ST12 Steam Enhanced Extraction: Has criteria for termination of Steam Injection Been Met?

Status as of 11/6/15 Weekly Progress Report

Progress Report
 Eastern Community Remediation Project Phase 10/2015
 November 6, 2015

Figure 26. NAPL Screening Results and Calculated Benzene Concentrations – Upper Water Bearing Zone

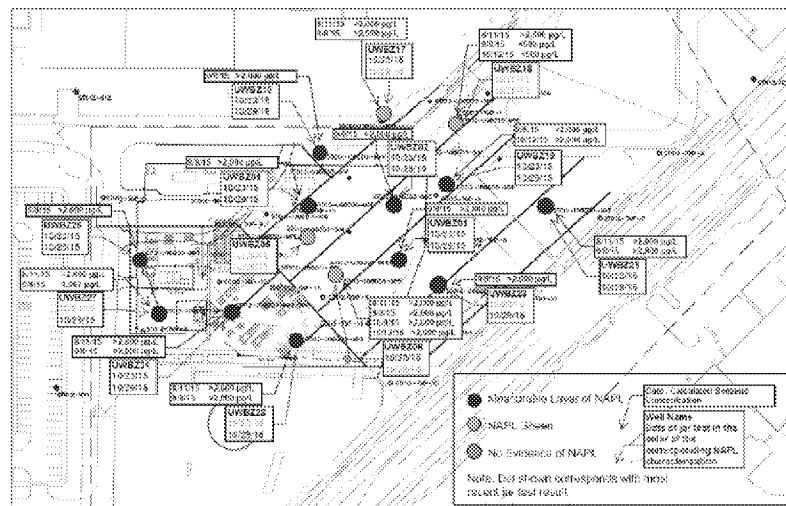
Benzene Concentrations in UWBZ exceed 500 µg/L; significant NAPL present, Criteria has not been met for UWBZ

Figure 27. NAPL Screening Results and Calculated Benzene Concentrations – Cobble Zone

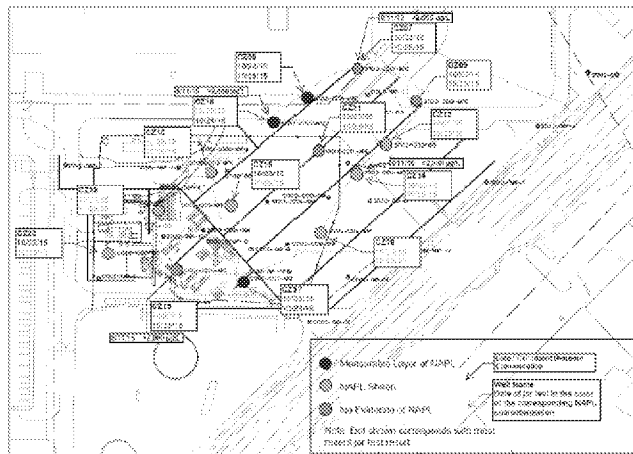
Benzene concentrations Exceed 500 µg/L in CZ, NAPL present; Criteria has not been met for CZ

Commented [DE4]: Add, EPA considers 100 ug/l of benzene in groundwater an appropriate target for a successful remediation, and would not support terminating steam treatment before the stated target (100 – 500 ug/l) is reached.

Figure 4. Daily Mass Removed

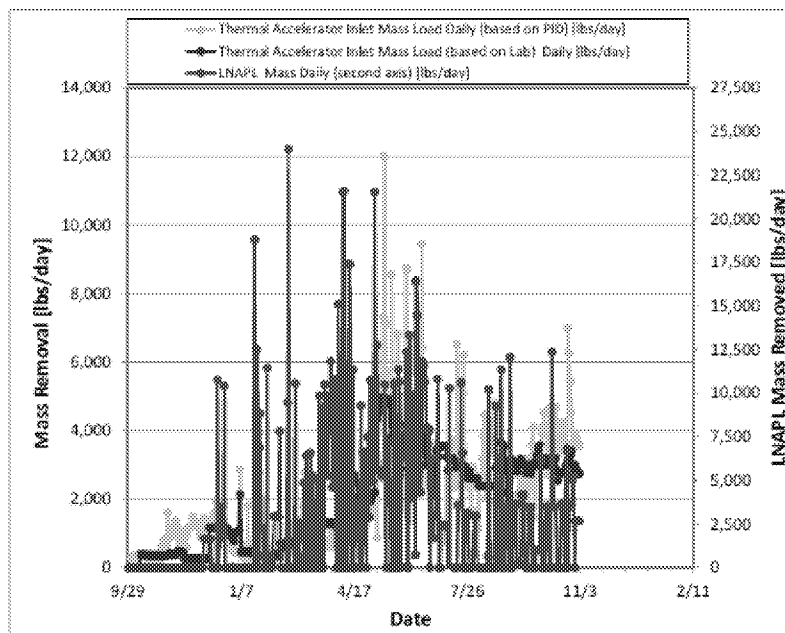
LNAPL recovery is 30% of peak removal rate; vapor recovery is 50% of peak removal rate; Criteria for termination of steam injection has not been met

Commented [DE6]: Add, EPA considers the criteria of 10% of the peak mass recovery to be high compared to the mass recovery rates that have been used to support thermal treatment termination at other sites. We cannot support termination of treatment when thousands of pounds of contaminant mass are being extracted daily.

Figure 6. Average Soil Temperatures

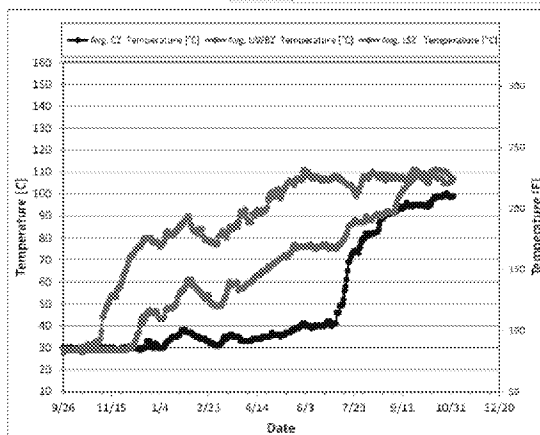
Criteria for Boiling Temperatures has just barely been met.

Commented [DE10]: According to slide 20 from Oct 15, the target temperature for the CZ is ~ 100C, which has almost been met. The target for the UWZ is ~114C, which I don't believe has been met. The target for the LSZ is ~134C, which has not been met.
